WABUSH 3 OPEN PIT MINE PROJECT

Environmental Impact Statement Amendment

Iron Ore Company of Canada

March 2015

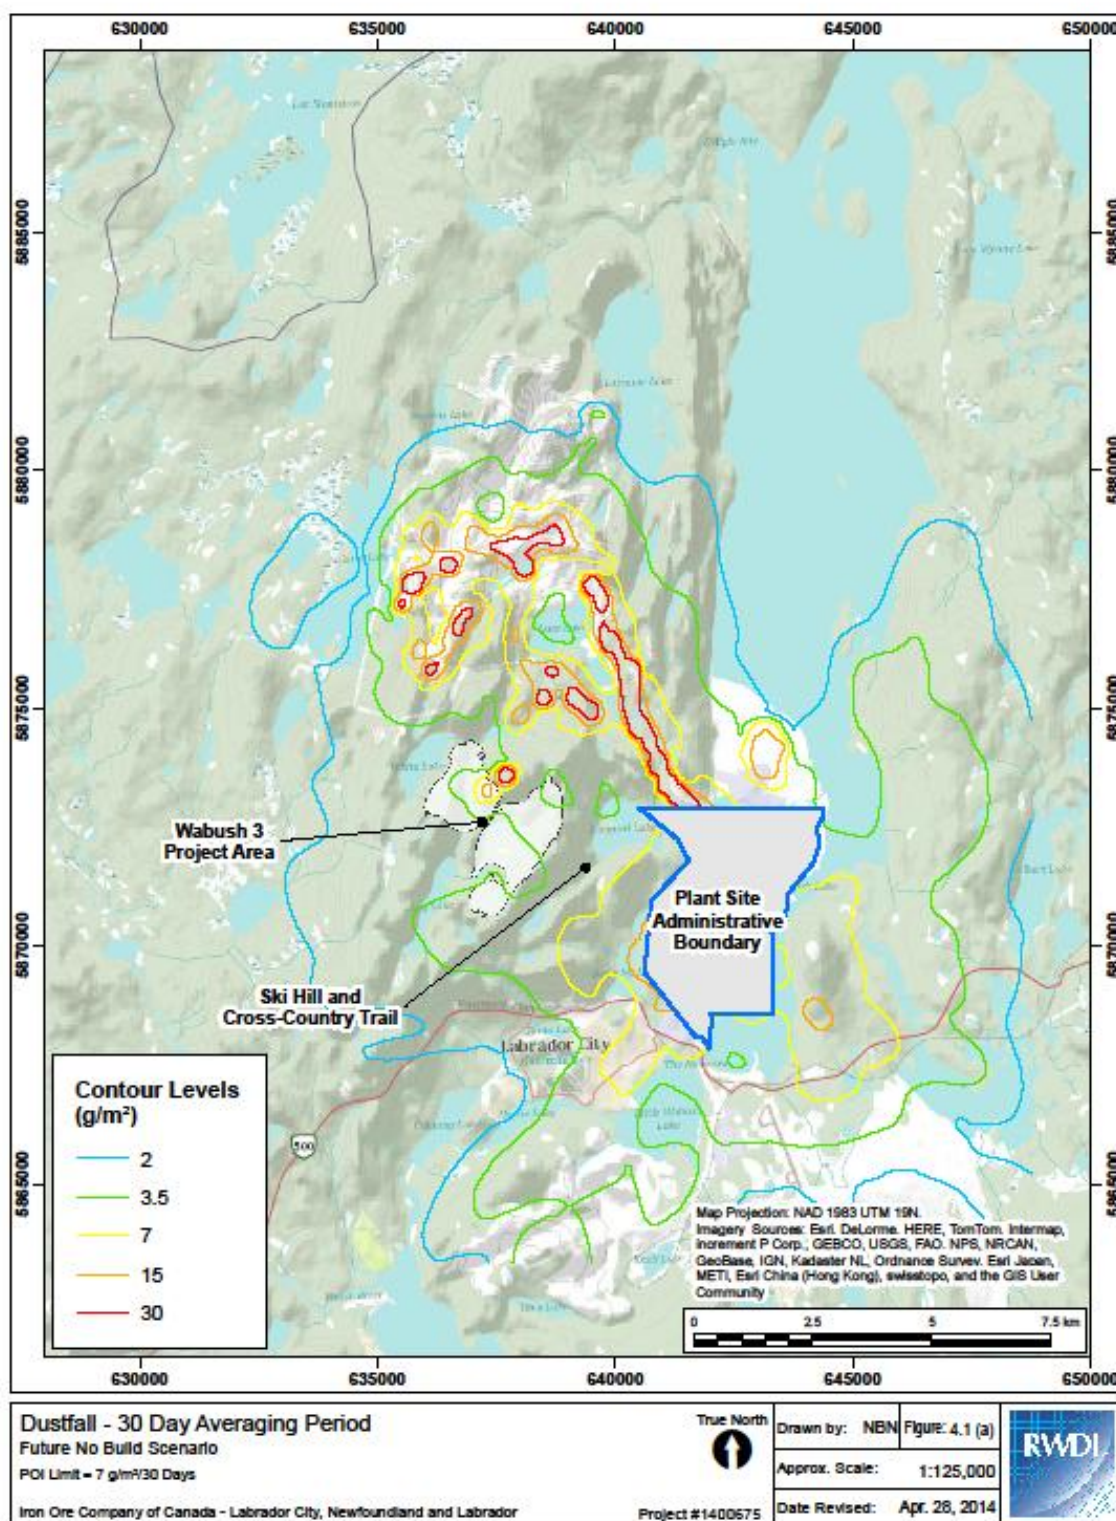
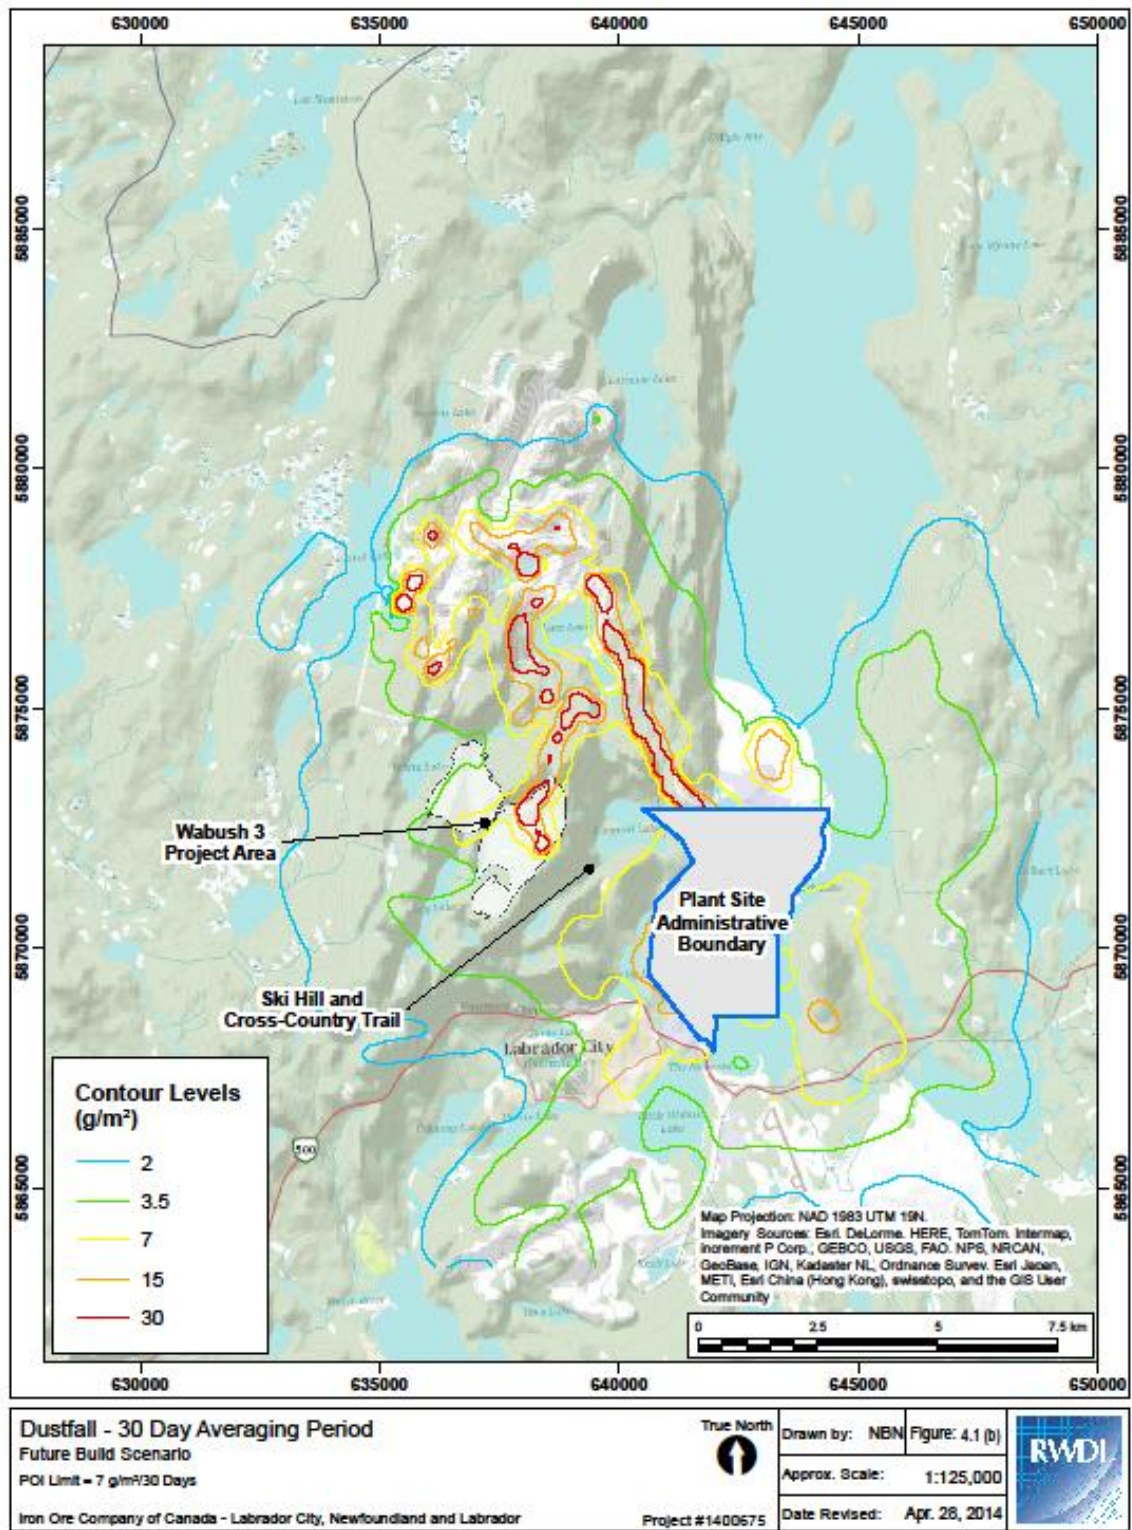
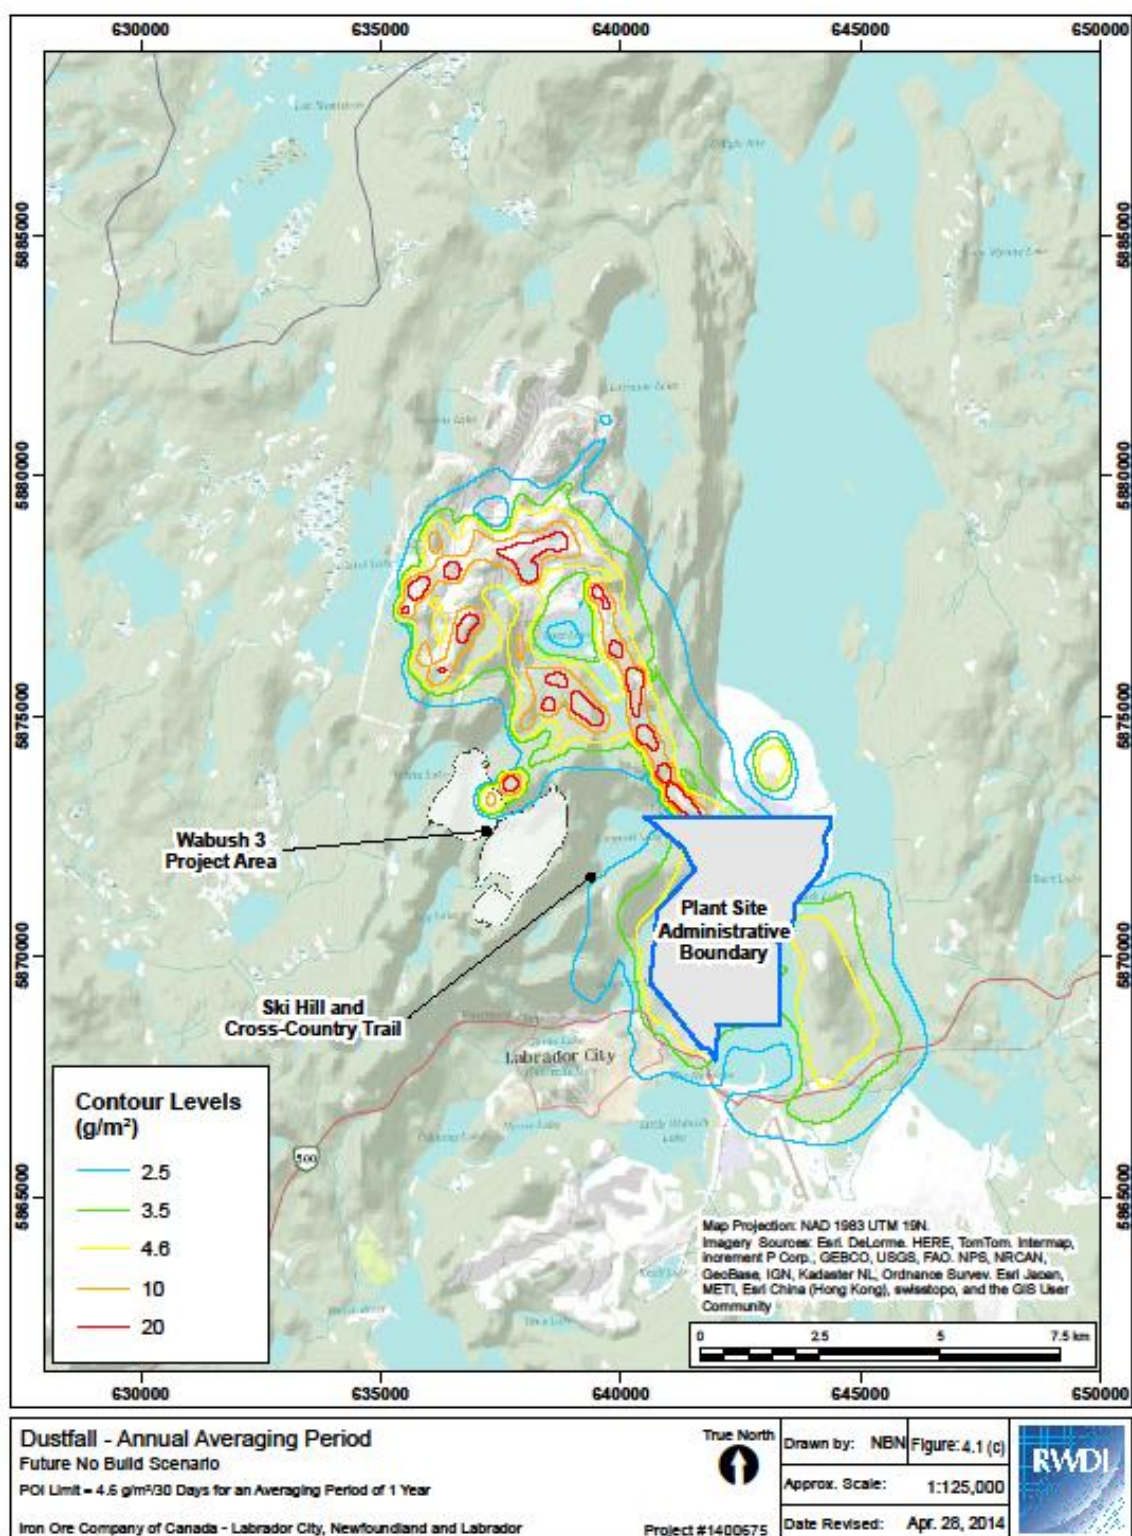
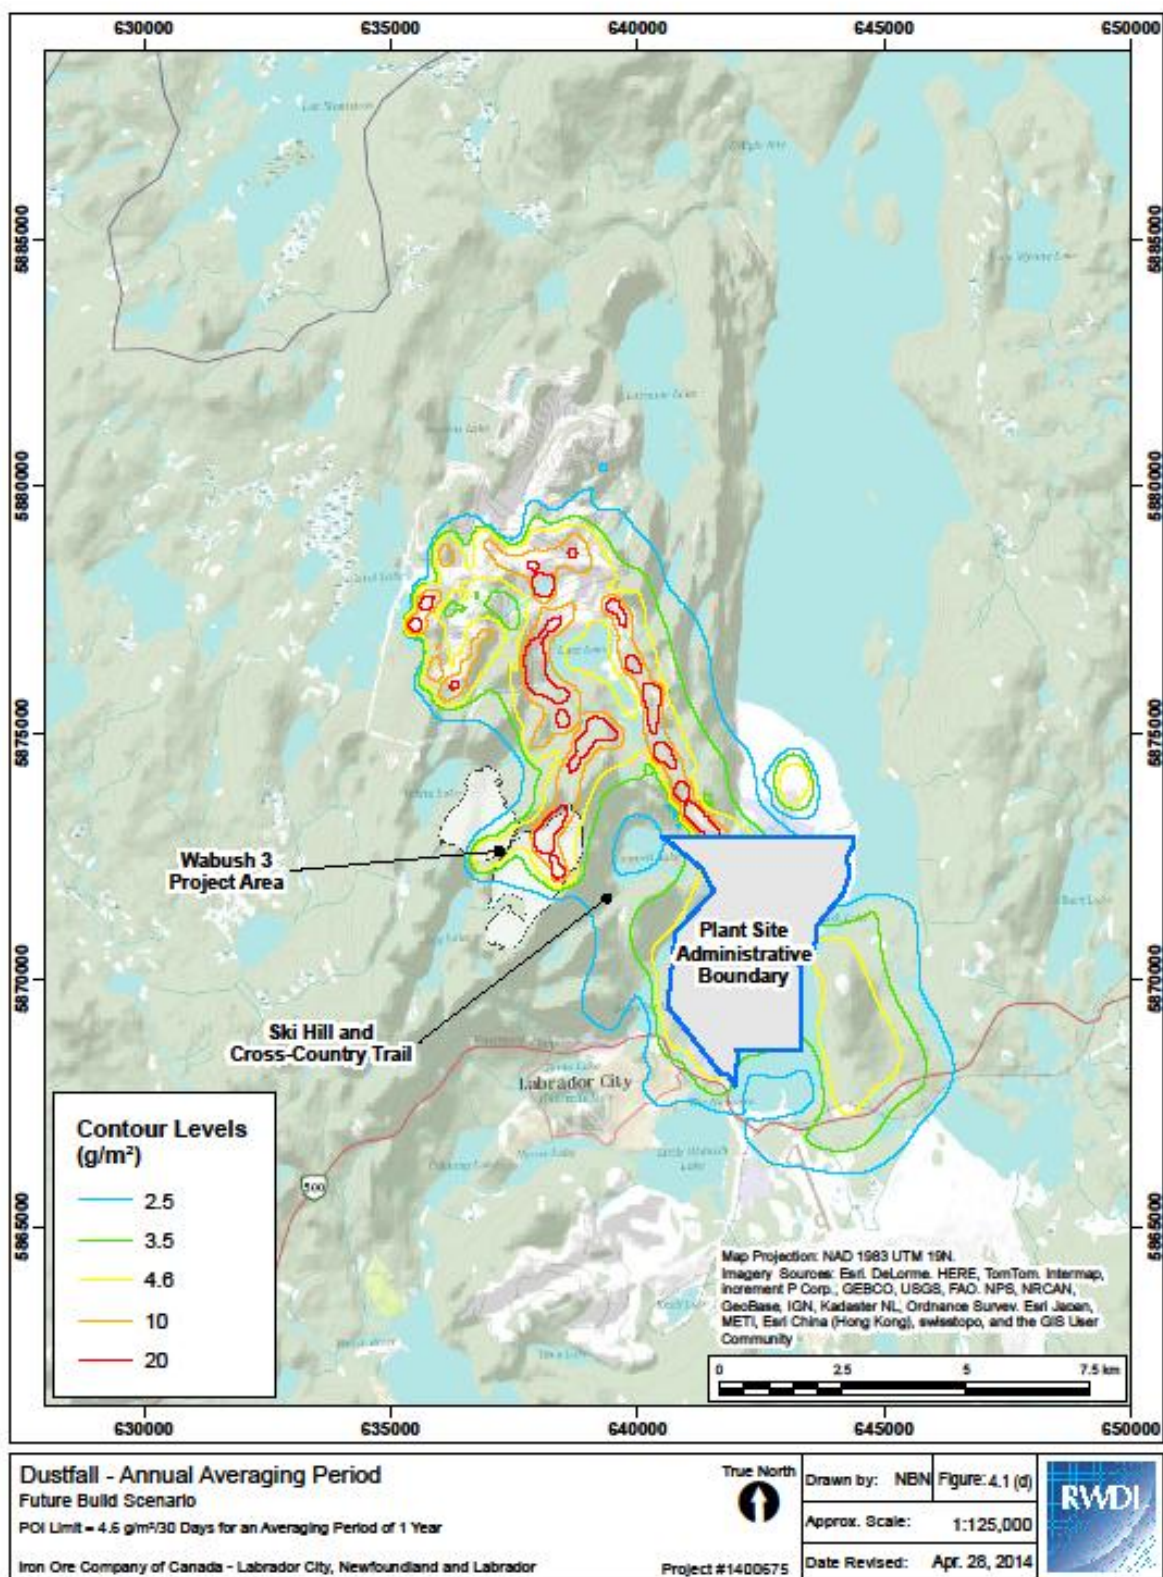
Confirm that the Beverly Lake Watershed is outside the deposition area of the Wabush 3 project.

The Air Dispersion Modeling performed by RWDI (EIS – Appendix 6 and Chapter 10) describes the deposition area for Wabush 3 and compares the two scenarios for Wabush 3 - in operation (Future Build) and not in operation (Future No Build). Figures 11 – 38 in Appendix 6 provide isopleths of concentrations for various timeframes for Total Suspended Particulates (TSP), PM₁₀, PM_{2.5}, SO₂, CO and NO₂. Subsequent to the EIS preparation, figures were prepared for dustfall levels and are included in this response (RWDI Figures 4.1a – d). Predicted air contaminant levels near Beverly Lake are virtually unchanged between the Future Build and Future No-Build scenarios. These results reflect that the Wabush 3 Project is not a major source of air emissions and that air quality in the Beverly Lake area would be more influenced by the adjacent IOC plant operations. Given that water quality is currently very good, no changes in water quality due to particulate deposition or other air contaminants from the Wabush 3 Project are anticipated.

Figure 1 Distances from the Overburden Storage Area to the Dumbell and Beverly Lake Watersheds

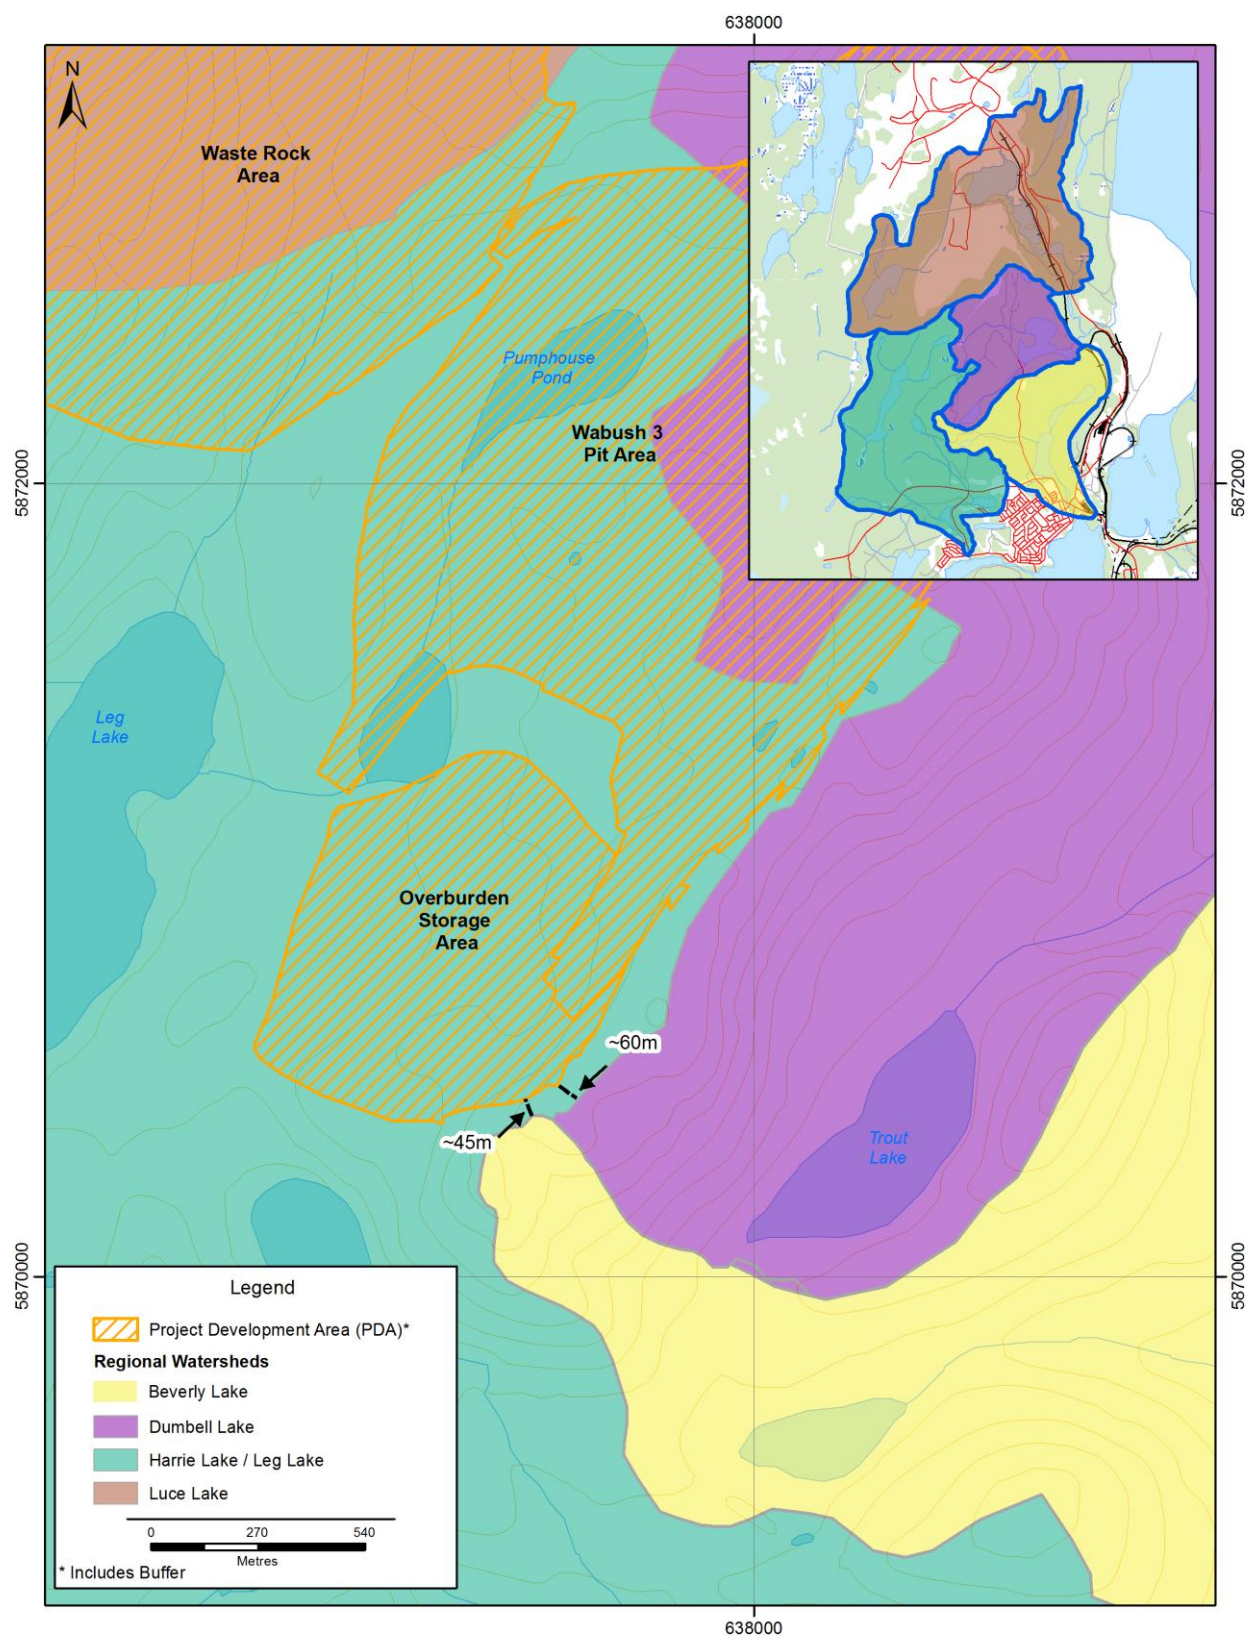
The Town needs firm confirmation that groundwater management/control during initial pit development will ensure that the groundwater gradients are controlled such that there is no movement of affected groundwater due to blasting residues from the pit development activities that will reduce the water quality in Dumbell Lake and Beverly Lake.

In addition, the locations of the waste rock and overburden stock piles were specifically chosen to be outside of the Dumbell Lake watershed. The runoff from the waste rock will flow mainly towards the White Lake sub-watershed within the Luce Lake watershed, with some runoff towards the Leg Lake watershed. The runoff from the overburden stock piles will occur entirely within the Leg Lake watershed.

Figure 1 shows the location of the waste rock and overburden stockpiles with respect to the watershed areas in the Wabush 3 Project.
